**AMENDMENTS TO THE DRAWINGS:**

## **REMARKS**

### **Summary of the Response**

Fig. 4

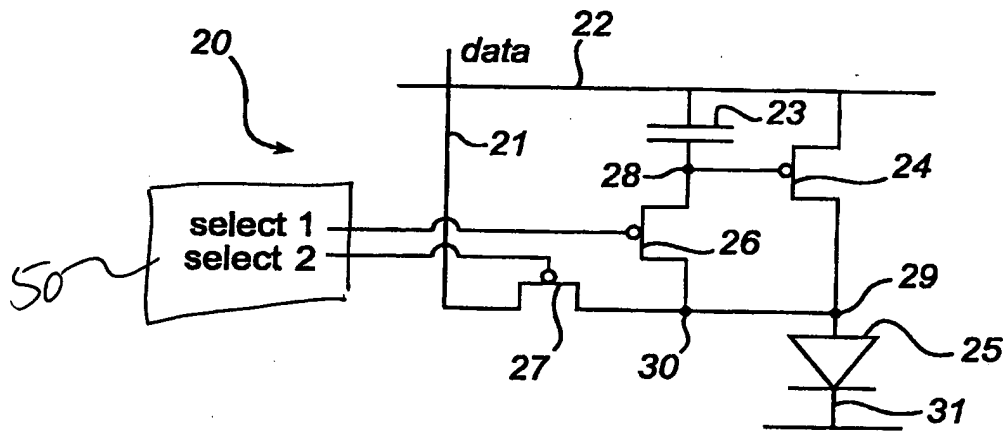
Fig. 4 and Fig. 5 have been amended to include a schematic representation of controller 50 and controller 51, respectively. This does not add any new matter, as the controller corresponds to controller 9 disclosed in reference to Fig. 1. The switches described in the corresponding sections of the specification are controlled by these controllers. The specification has been amended to make specific reference to the controllers 50 and 51.
